CITY OF TAYLOR, TEXAS PLANNING AND ZONING COMMISSION MEETING

August 8, 2023, 6:00 P.M.

**City of Taylor
PZ-2023-1633
3811 N. Main St.
Subdivision Improvement Plans
Staff Report**

Staff has completed its review of plans for the 3811 N. Main St. Subdivision Improvement Plan that is to be located at 3811 N. Main St., Taylor, TX 76574. At this time the plan set has been Denied based on staff comments below. Please coordinate with Shai Roos to set up a Comment Resolution Meeting. Please be aware that the next resubmission date will be on August 18th.

RCR-TAYLOR LOGISTICS PARK PHASE 1 AMENDING PLAT 3

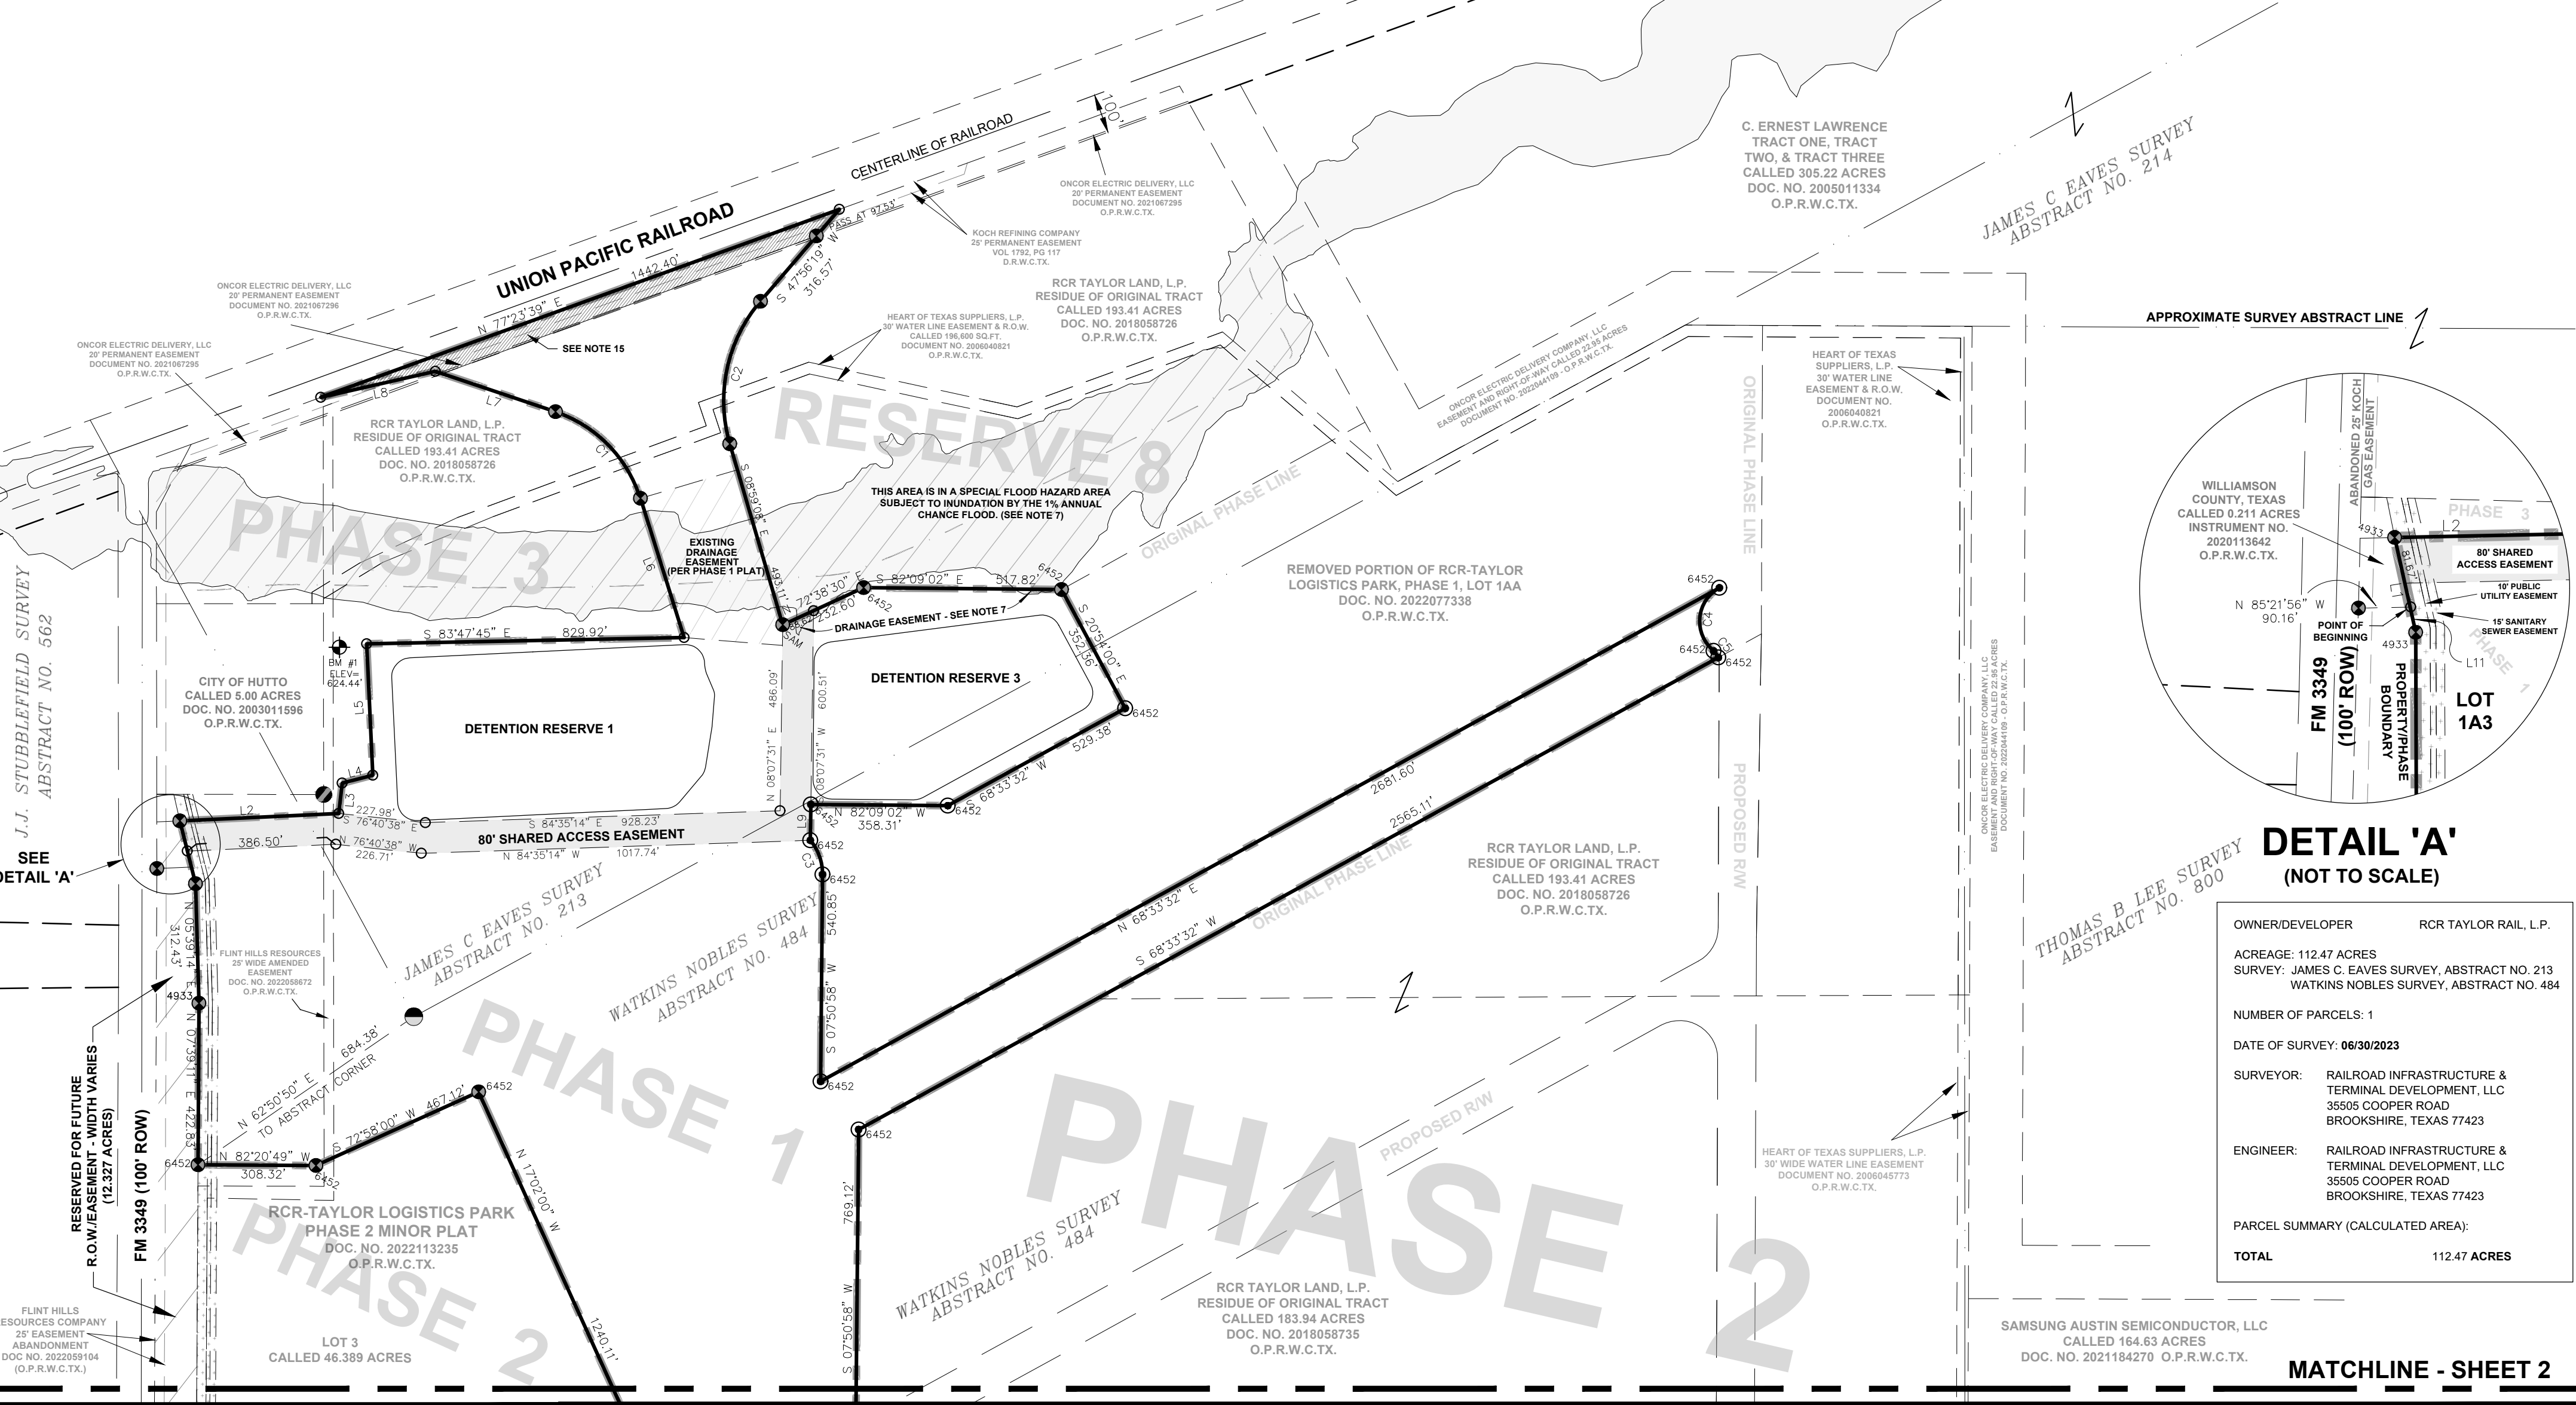
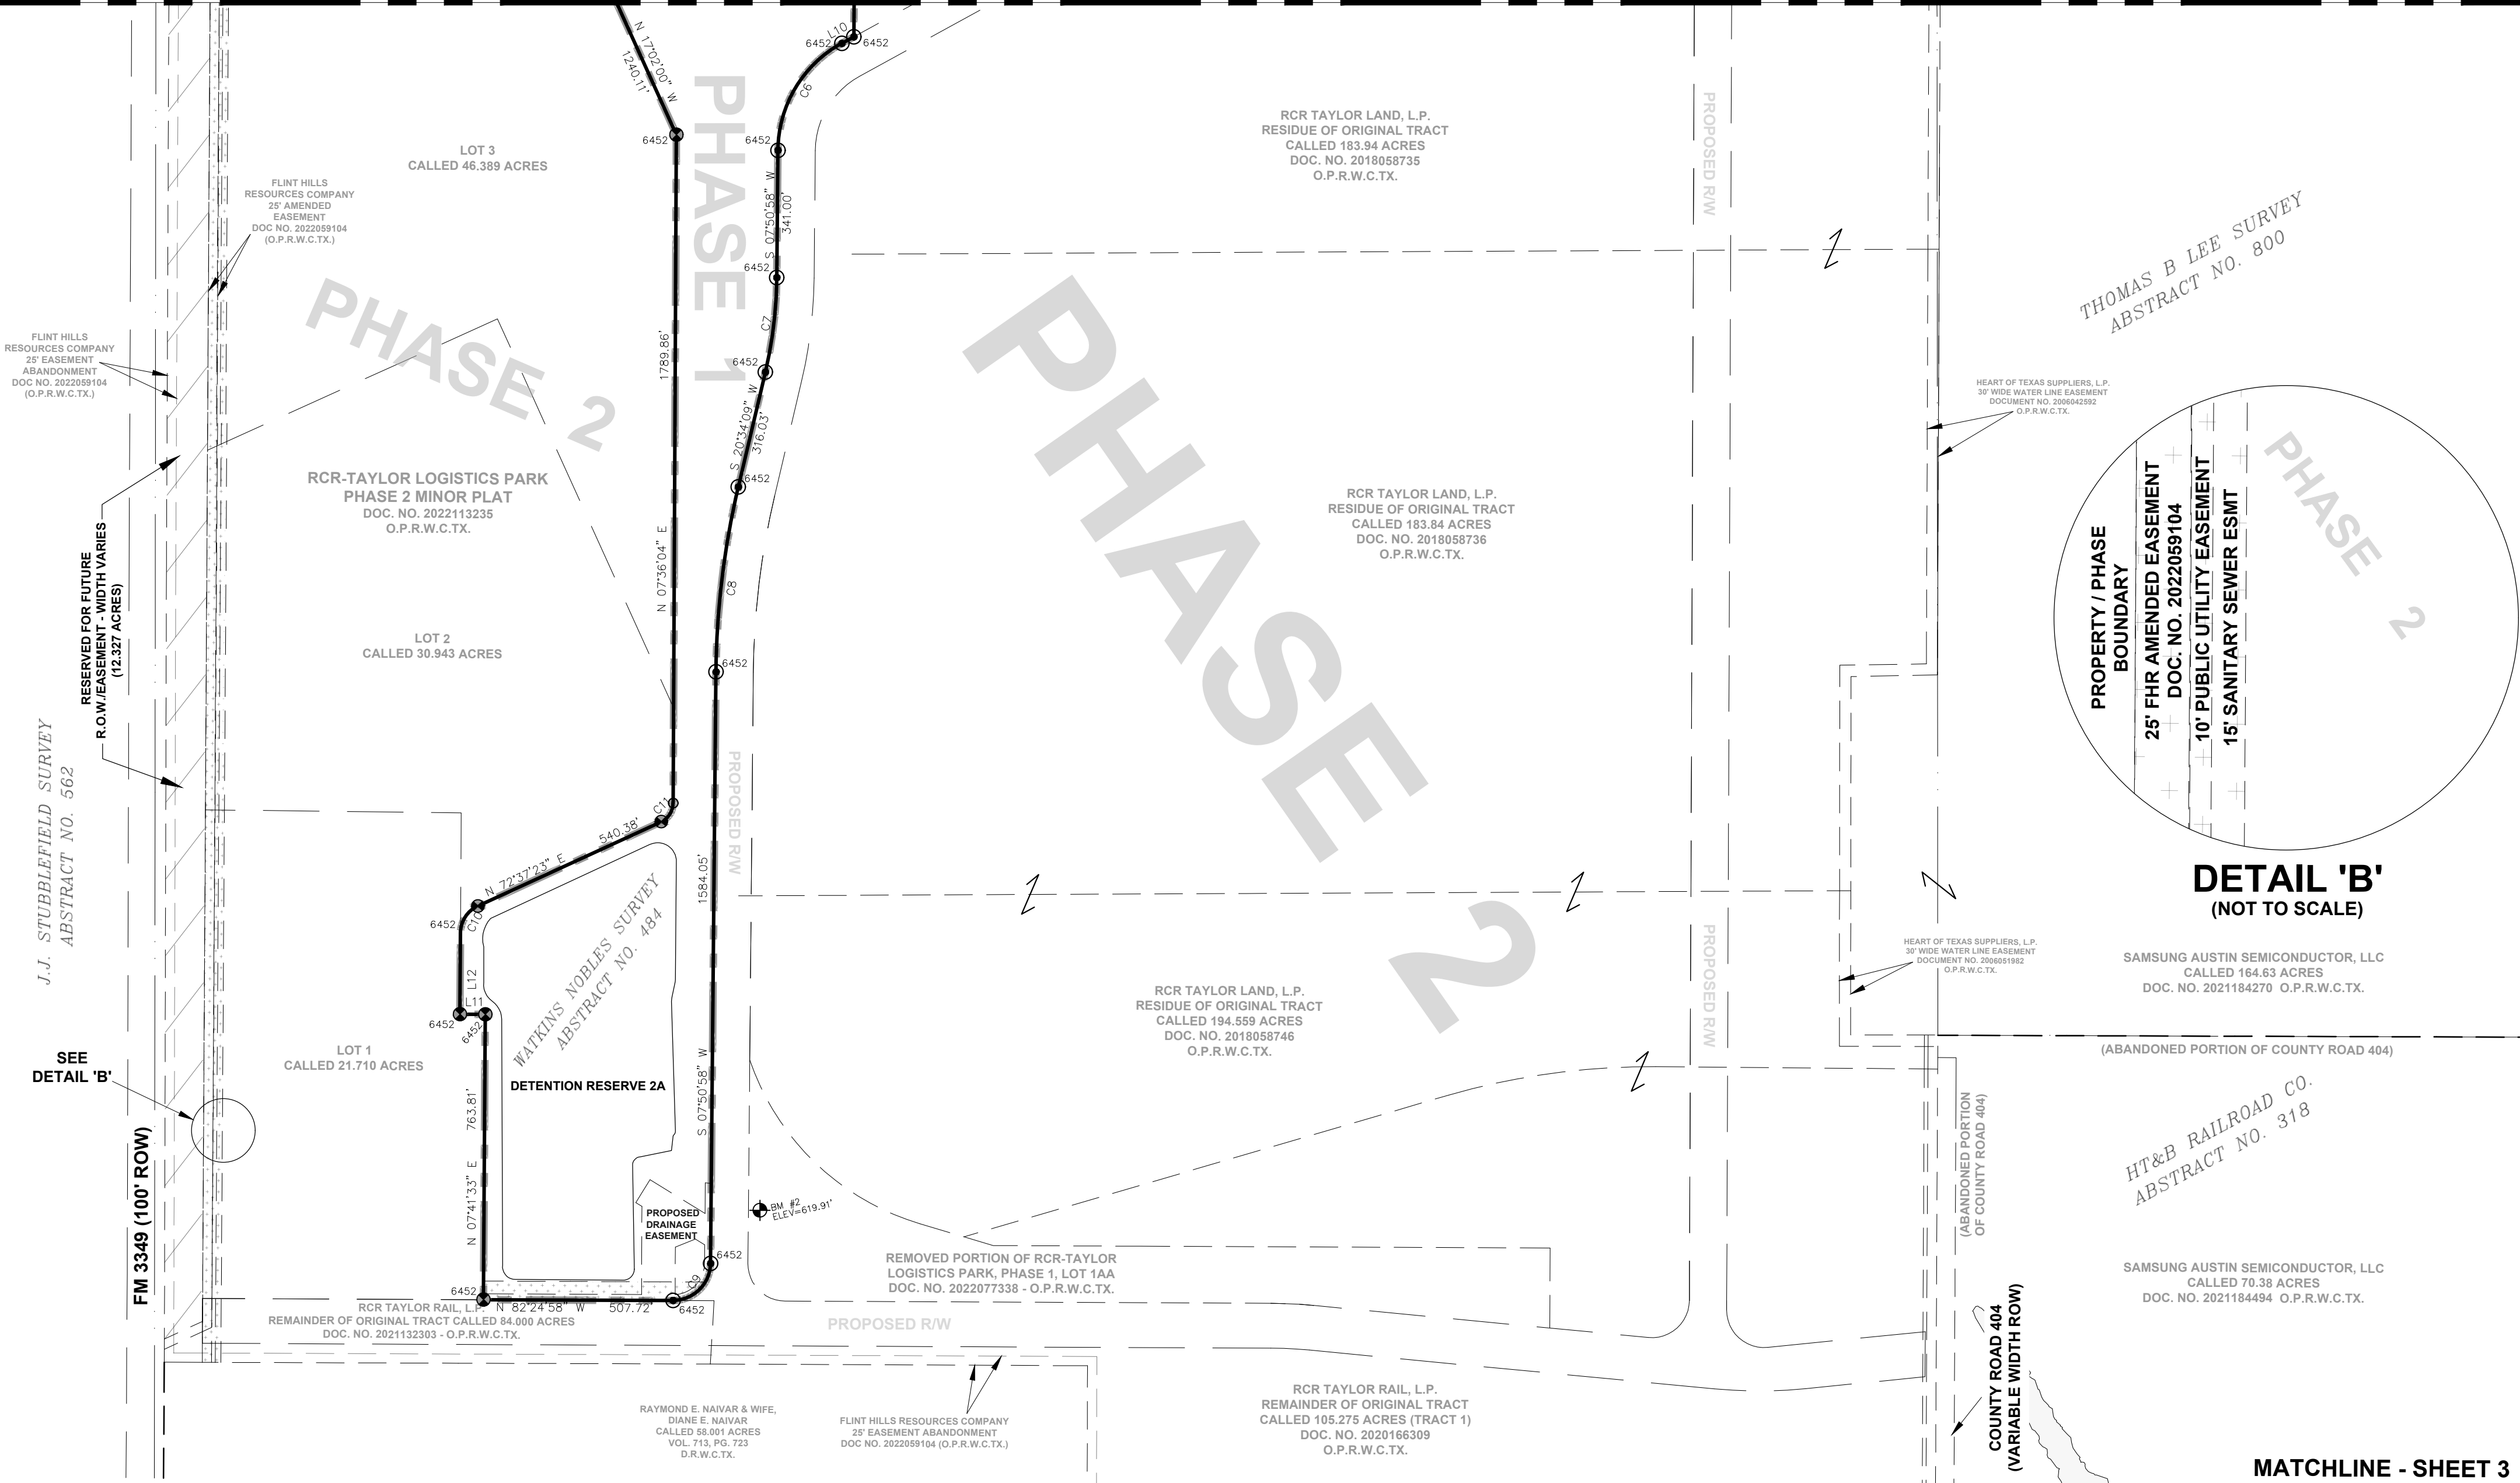
1. Sheet 1 of 4 - Show location of all existing railroads within the plat per Subdivision Ordinance Sec. 3.3 (Typical).
2. Sheet 1 of 4 - Verify if private water line easement is needed for Lot 1 Blk 3.
3. Sheet 1 of 4 - Verify hatching shown on either side of the drainage easement from Phase 1. Is this area included in the drainage easement?
4. Sheet 2 of 4 - Verify and show location of sidewalk on plat.
5. Sheet 2 of 4 - Show reference of Access Easement on Naivar tract.
6. Sheet 2 of 4 - Verify continuity of easement and reserve 2a for outfall pipe.

7. Sheet 3 of 4 - Verify if this area is to be included in this plat. The limits of proposed replat area of Phase 1 are shown on sheets 1-2. If required, provide a north arrow for this sheet.
8. Sheet 3 of 4 - Missing description of Curve C3.
9. Sheet 3 of 4 - Description does not match drawing and following course and Curves C4, C5 is missing description.
10. Sheet 3 of 4 - Verify and revise descriptions shown. The descriptions provided are missing courses and does not match the plat drawing.
11. Sheet 3 of 4 - Verify and update bearings and distances marked below in paragraphs 3,5,8,9 and 13.
12. Sheet 4 of 4 - Note 16 - Verify if Lot1, Blk 3 of Phase 2 will also be provided access and if a private water line easement is to be included for this same lot.
